Model: See Affected Units	Jul. 2, 2024
Serial #: N/A	
Product Bulletin # CDS-011 Rev 2	
Alert

CDS Link Tilt operations with Stabilizer Kit and Coupler Plate Mount

Figure 1: CDS link tilt assembly

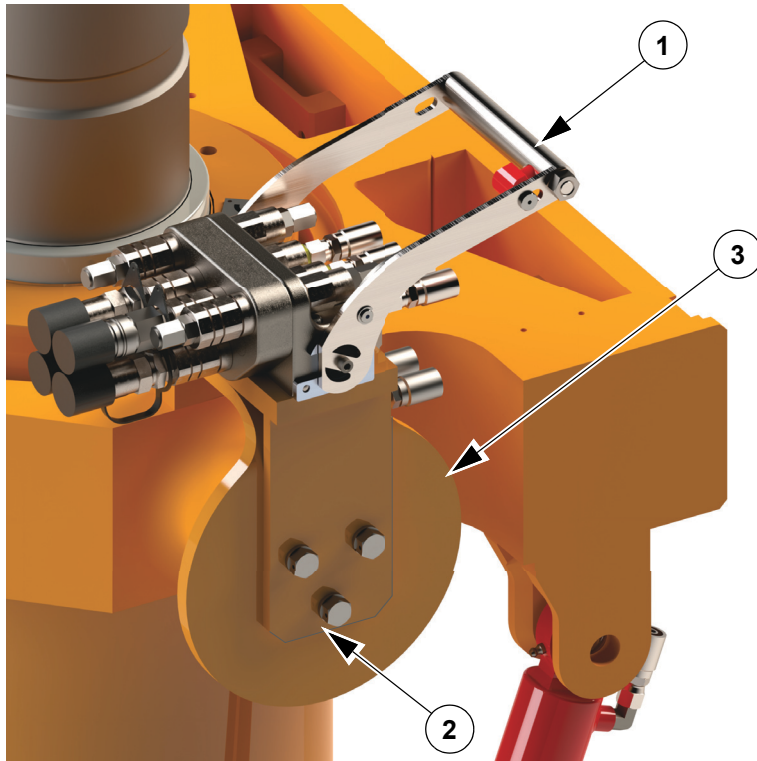
1. Disassemble Single Joints Links Stabilizer Kit #5104015 from the CDS Link Tilt Assembly.
2. Disassemble the Multi Coupler Plate #H16763 (1), Mount #DT24294 (2) and Guard #16062 (3) from the CDS Link Tilt Assembly (Driller's Side):

Figure 2: Modified mount

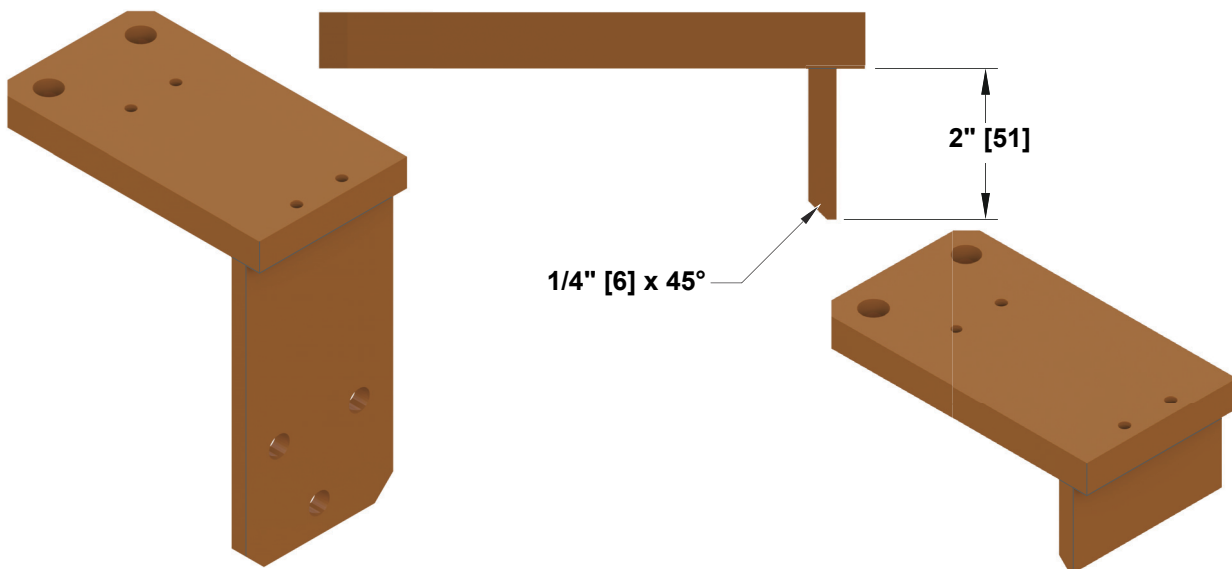
3. Modify Coupler Plate Mount #DT24294 to #DT24294M:

Figure 3: New mount weldment

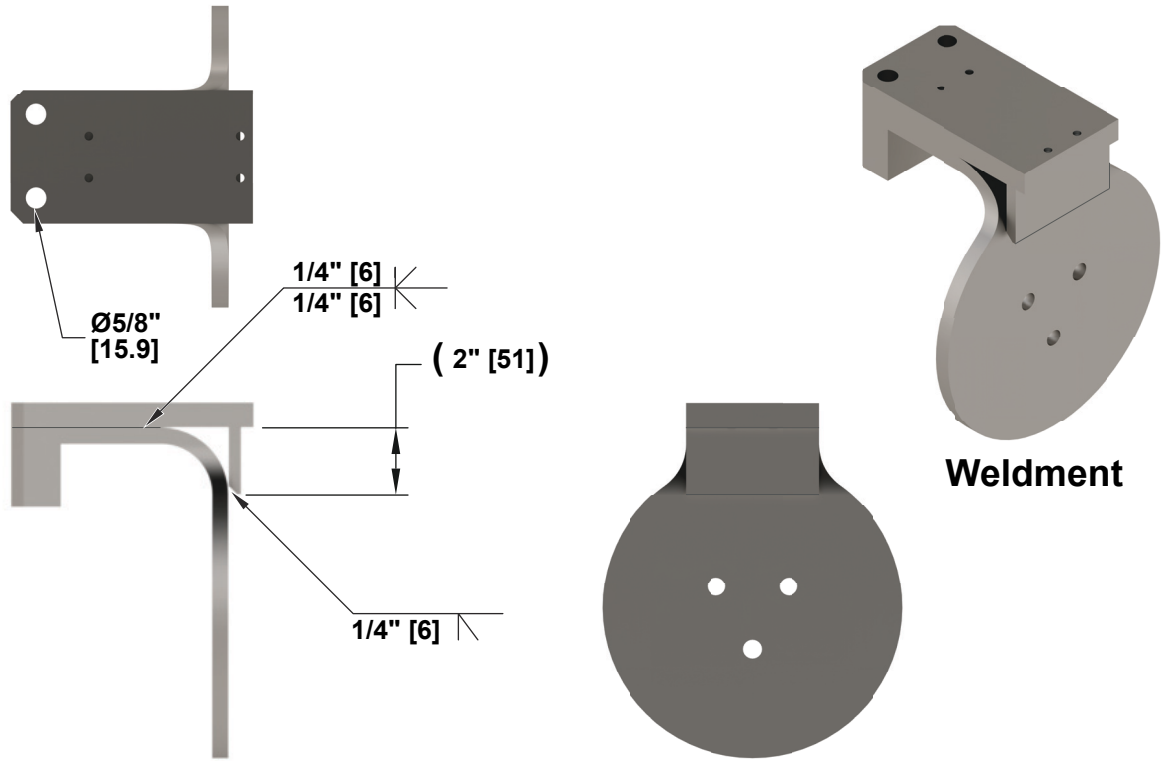
- Remove paint from modified Coupler Plate Mount #DT24294M and Guard #16062 and prepare for welding.
- Weld the modified Coupler Plate Mount #DT24294M to Guard #16062; Ensure the components' two (2) 5/8" holes are aligned:

Figure 4: Mount Painted

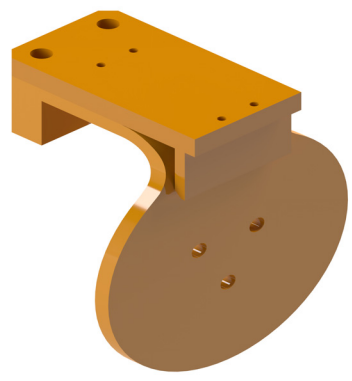
- Paint the modified Guard #16062M (c/w welded modified Coupler Plate Mount #DT24294M) Tesco Yellow as per ENG713.
